# DUKE POWER COMPANY

Reference: Oconee Nuclear Station  
Docket Nos. 50-269, -270, -287

RESPONSE TO REQUEST FOR ADDITIONAL INFORMATION  
CONCERNING TURBINE BUILDING FLOODING

TURBINE BUILDING FLOOD DRAIN  
GENERAL ARRANGEMENT  
EQUIPMENT AND ACCESS LOCATIONS  
FIGURE NO. 2

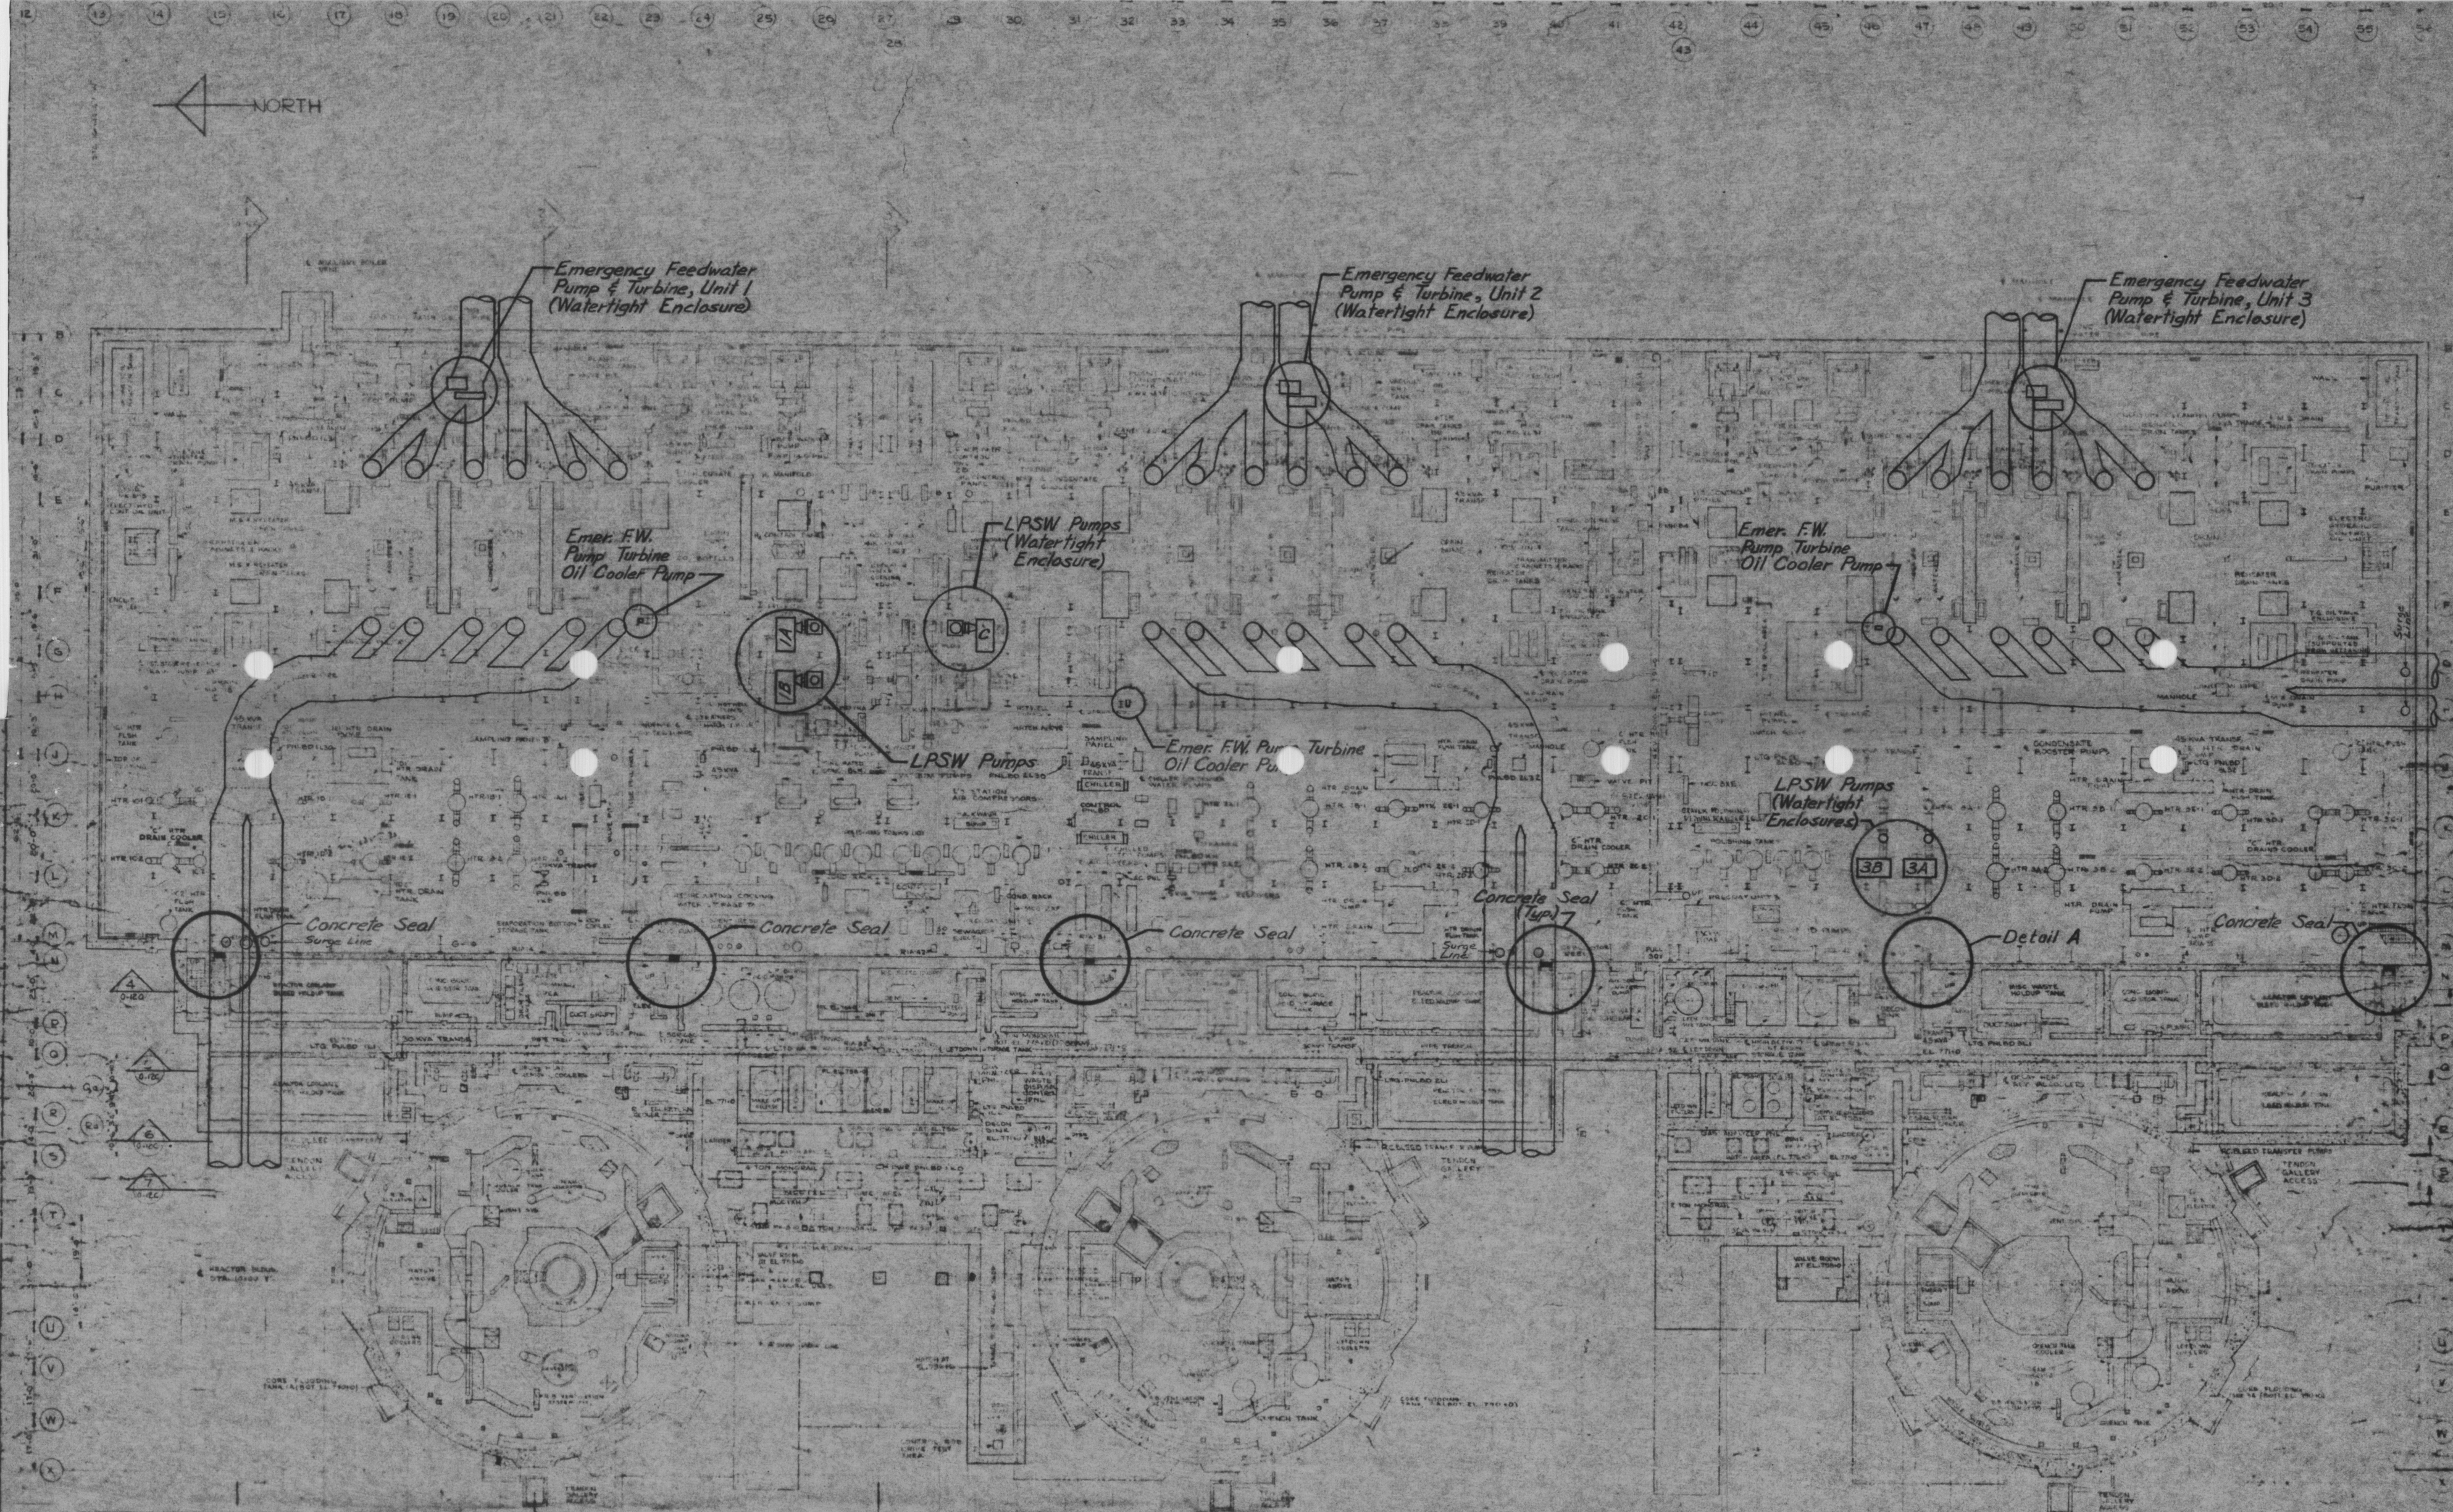
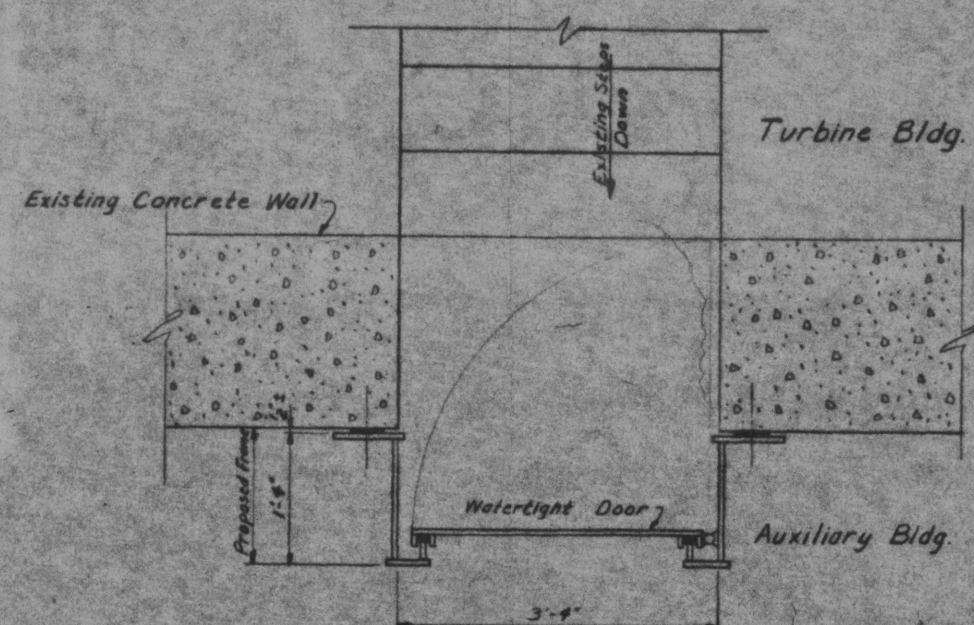
With the aid of appropriate plan and elevation views locate the components.

Identify and locate on drawings all flood water pathways that formerly existed between the turbine building and the areas housing essential equipment.

The equipment locations, both in plan and elevation views, are indicated on the attached Figure 2.

Figure 2 locates and identifies the major Turbine/Auxiliary Building wall openings which consist of six access doorways at the basement level. Minor pipe sleeve penetrations also exist below the maximum flood water elevation.

The CCW pump discharge butterfly valves have a closure timing of 60 seconds. Surge lines are present on each CCW System approximately 90 feet upsgream of the main condensers as shown on Figure 2. Round-trip travel time for a propagating water hammer wave from the condenser area to the surge line is approximately .07 seconds and therefore the lines are fully engaged in dampening water hammer and surge events which could be created at or pass through the exposed portions of the CCW System in the Turbine Building.

TURBINE BUILDING FLOOD DRAIN  
CCW CROSSOVER  
LPSW CONNECTIONS  
FIGURE NO. 3

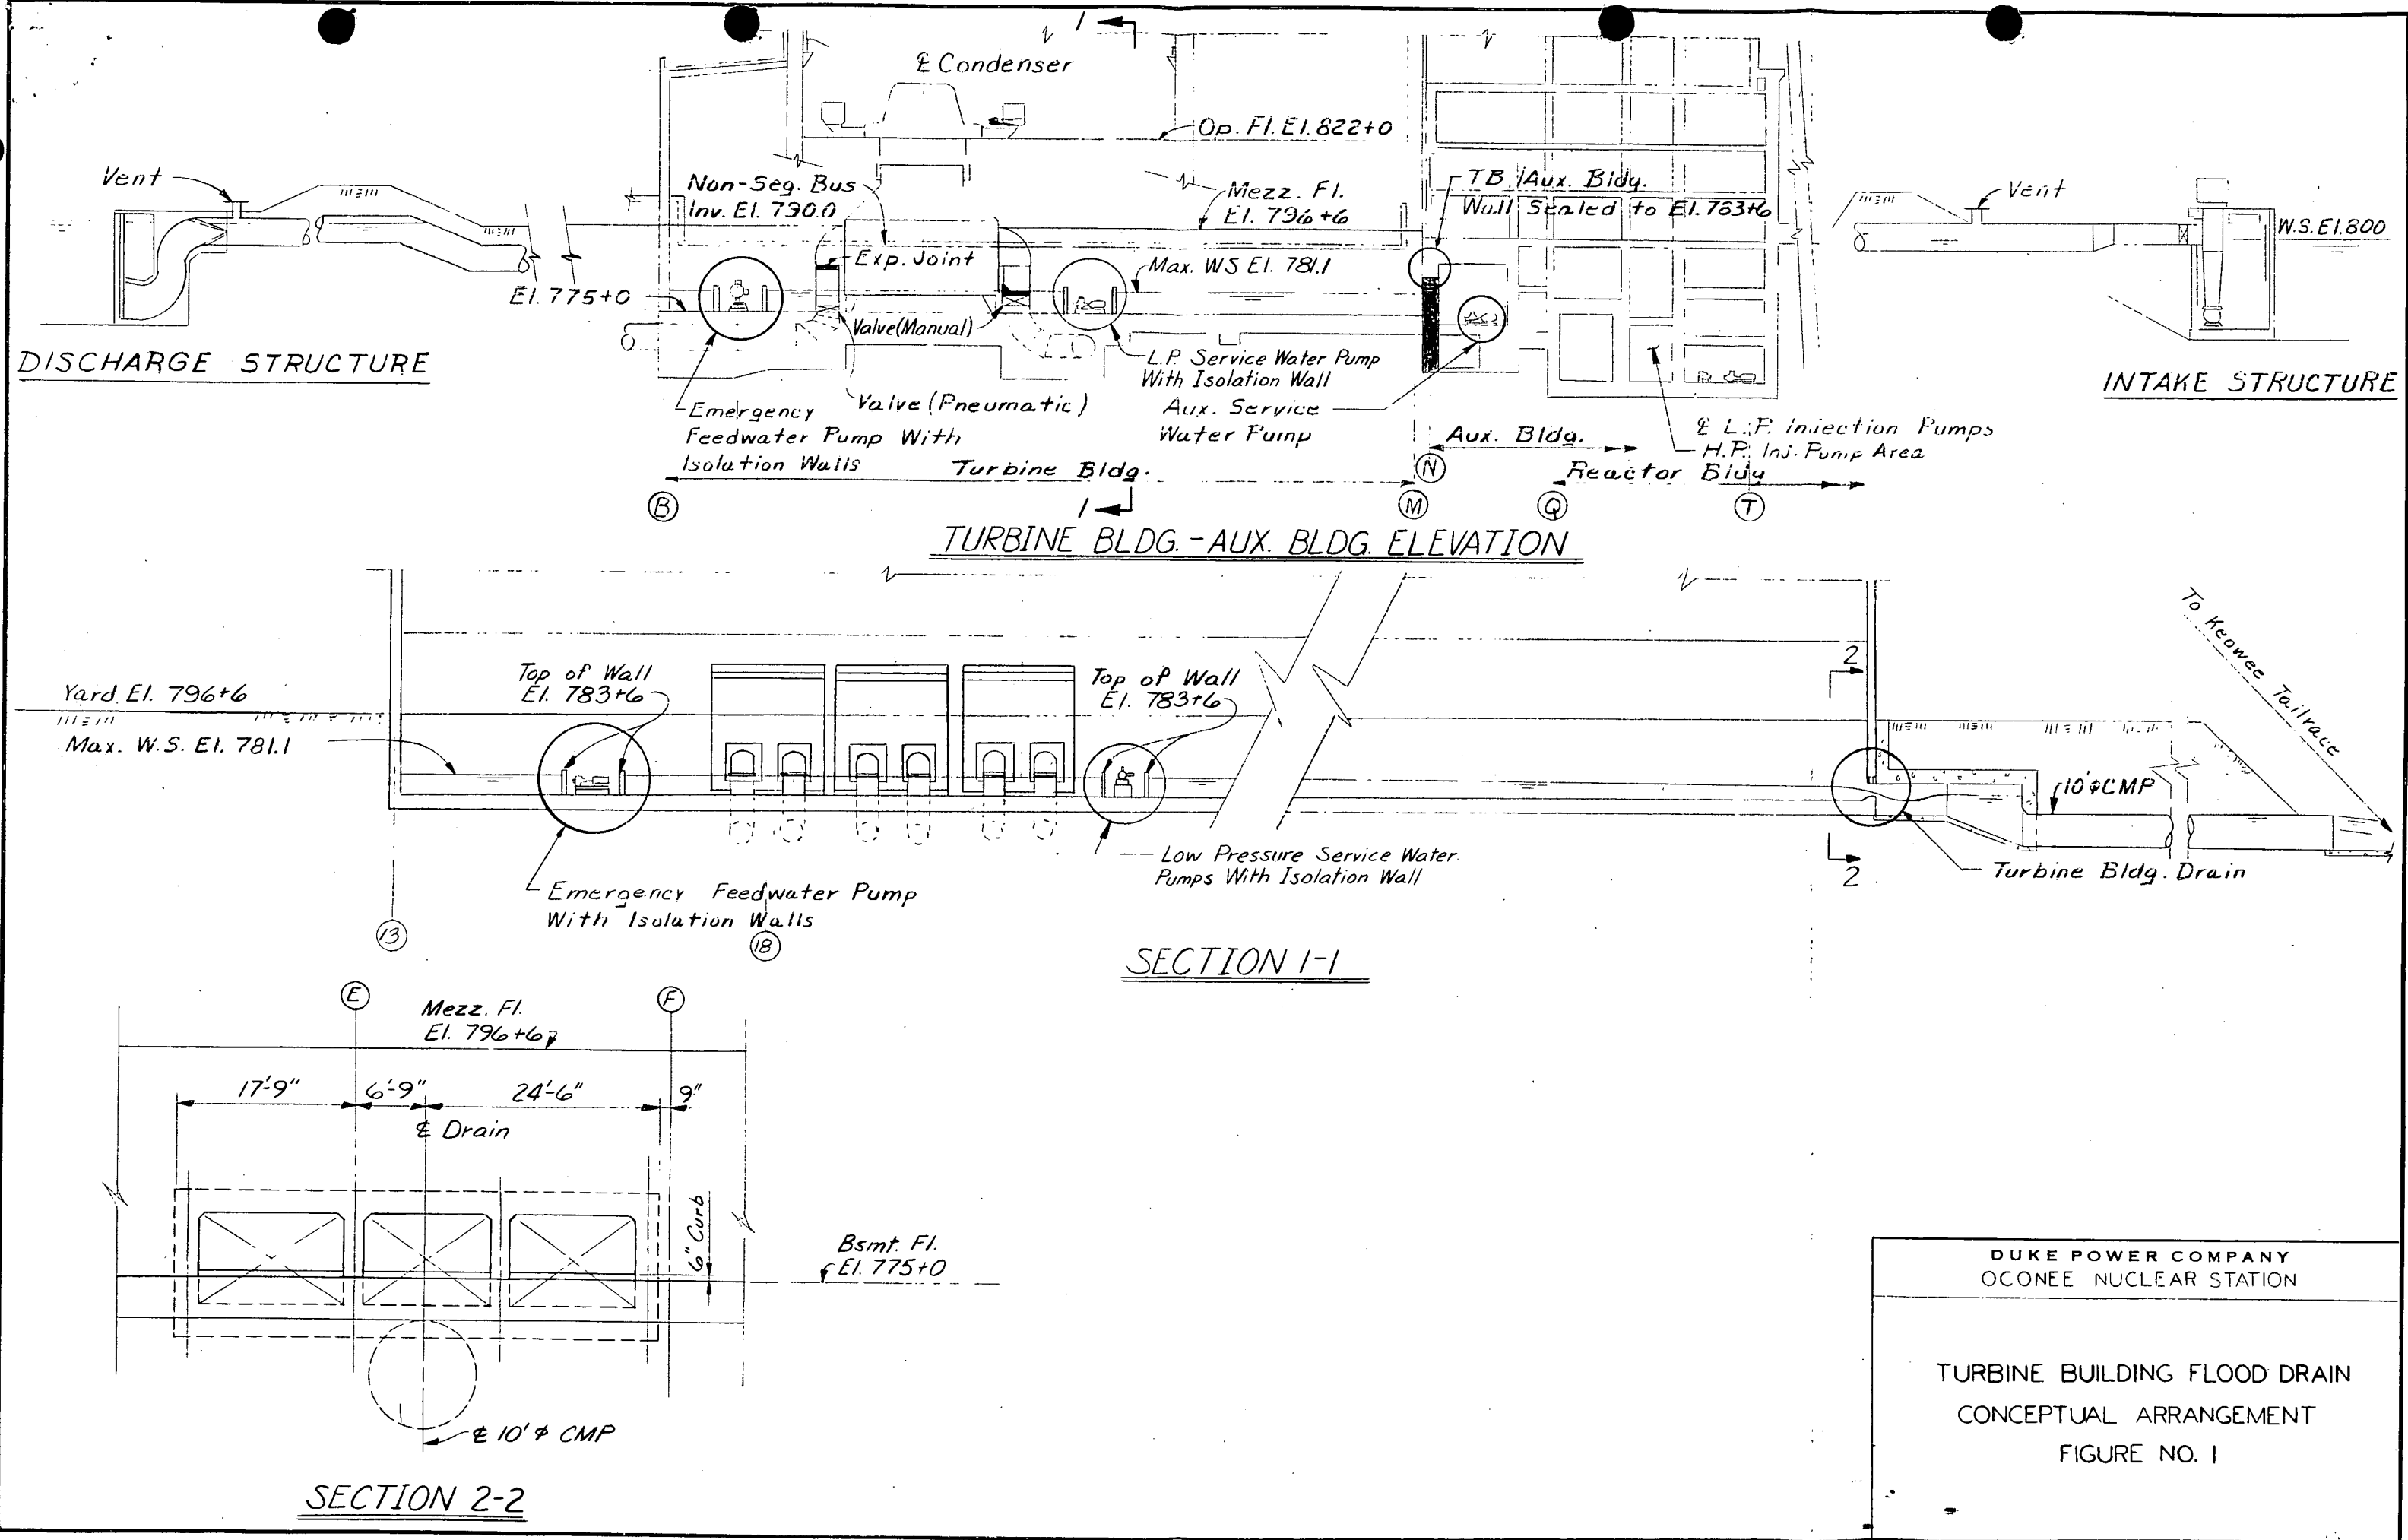
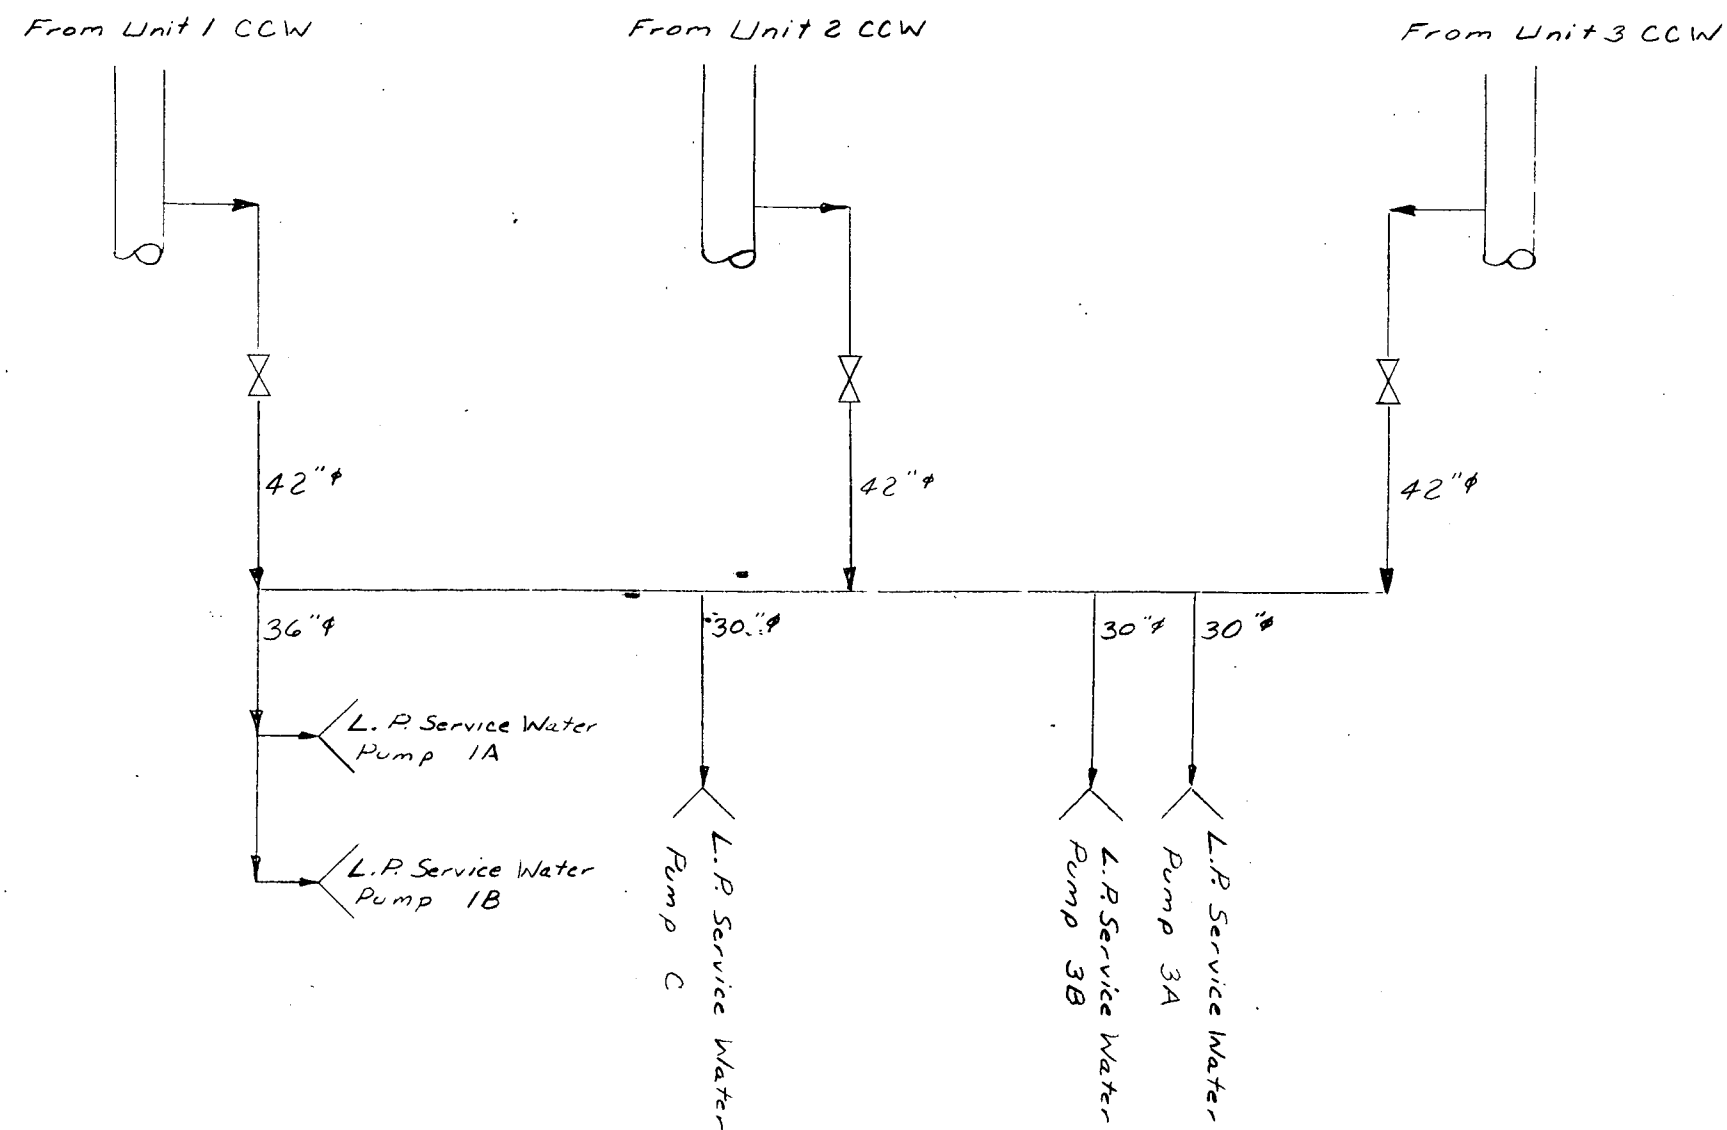
With the aid of a diagram make layout of the Condenser Cooling Water Systems (CCW) for Units 1 and 2, show the take off points on the crossover line between Units 1 and 2 for the High Pressure Service Water and Low Pressure Service Water Systems. In addition, since these systems are essential service water systems provide a discussion which demonstrates that the functioning of these systems are immune to any single failure in the Condenser Cooling Water System, crossover line, or the condenser box non-seismic butterfly valves (termination point of the seismic Category 1 portion of the CCW system).

Figure 3 shows the CCW System for Units 1, 2, and 3, the cross-over line and the branch connections for the LPSWP's. No credit is taken in this analysis for the High Pressure Service Water Pumps and thus the connections for these pumps are not shown.

Various conservative net positive suction head calculations have been performed which indicate that any single failure to the CCW System piping, the condenser waterbox, crossover line, or the condenser waterbox non-seismic butterfly valves will not jeopardize the proper operation of the LPSWP's. The calculations were performed for both the minimum and maximum operating lake levels assuming breaks at elevation 775 in either the CCW pipe or the crossover line. The calculations proved that there was no deficiency in NPSH due to the effect of excess water flowing through the crossover line to the break location.

Each of the three crossover valves will be backfitted with reach rods. Thus, if a break occurs in the Unit 1 CCW pipe, the valves at the Unit 1 intake structure along with the Unit 1 crossover valve will be closed to isolate the leak. Unit 2 and 3 CCW Systems will continue to supply water to the LPSWP's. A break in any one of the units CCW System would be similarly isolated. The available NPSH will increase following this operation due to the lower flow through the crossover line.
